ARMoured CAR, DAIMLER, MKS 1 AND 2TECHNICAL HANDBOOK - MODIFICATION INSTRUCTION

1. This instruction concerns the fitting of an oversize bush to the fluid flywheel, rear casing, when necessary.

Fig 1 - Rear casing oversize bush

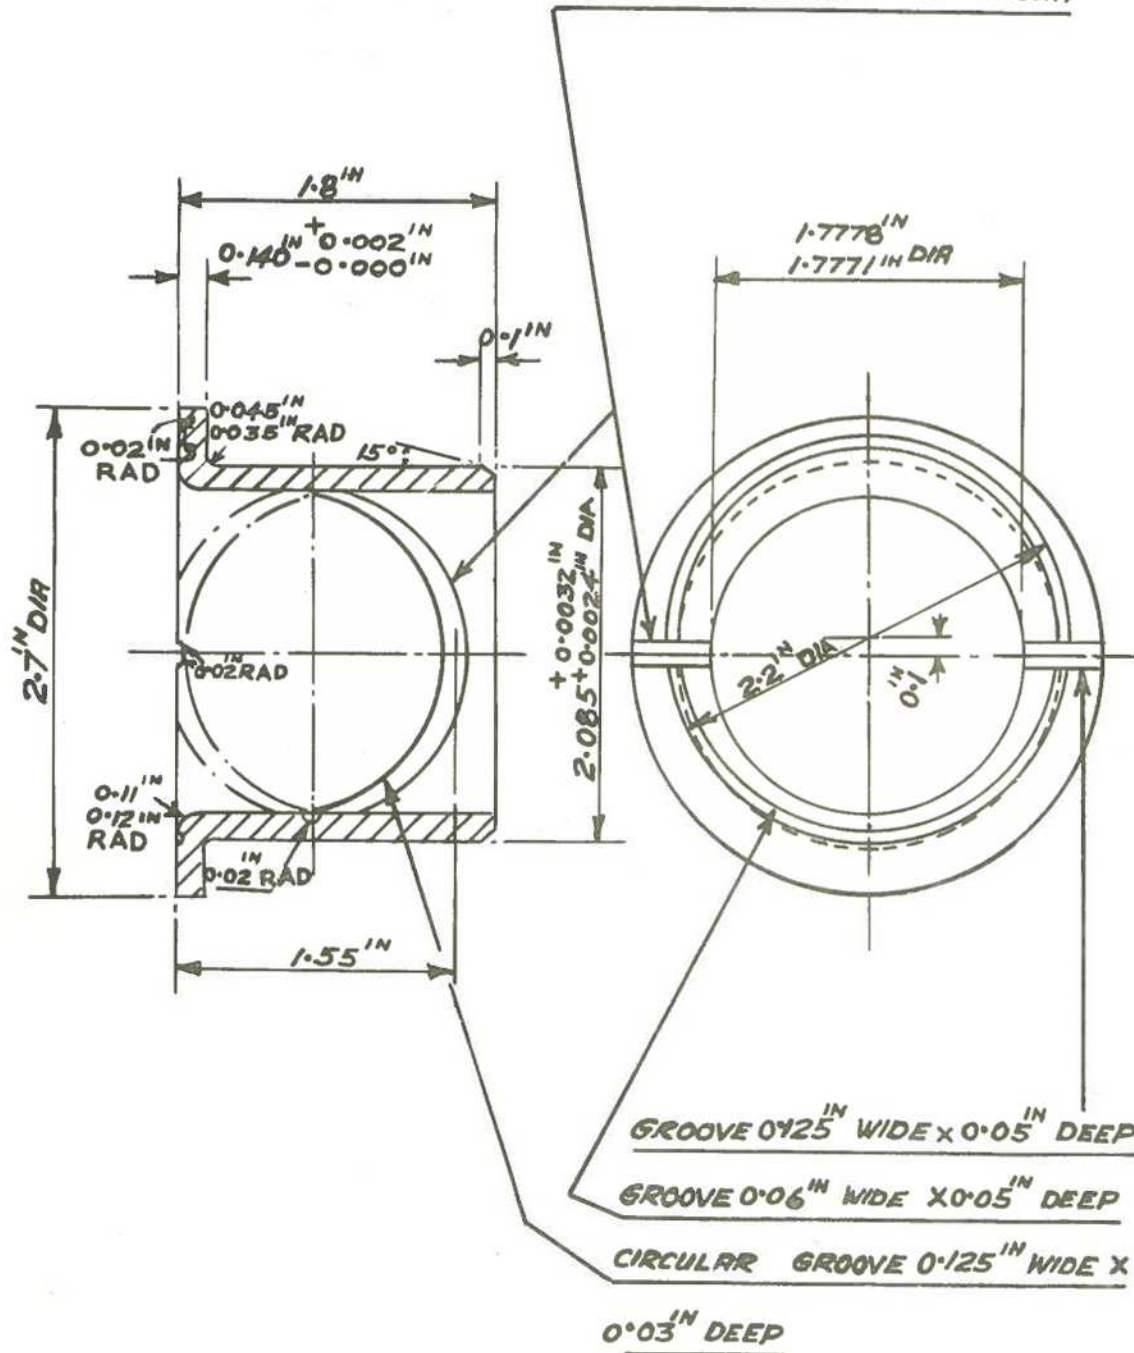
6. When the existing bush is found to be turning in the casing, it will be replaced by a bush manufactured locally.

- (a) Remove existing bush.
(b) Machine bearing housing to within the dimensions of $2.085^{+0.0006}_{-0.0004}$ inches.
(c) Manufacture oversize bush as detailed in Fig 1.
(d) Fit oversize bush to casing.

THIS GROOVE MUST BREAK INTO
THE FACE GROOVE AS SHOWN

MATERIAL:- PHOSPHOR BRONZE
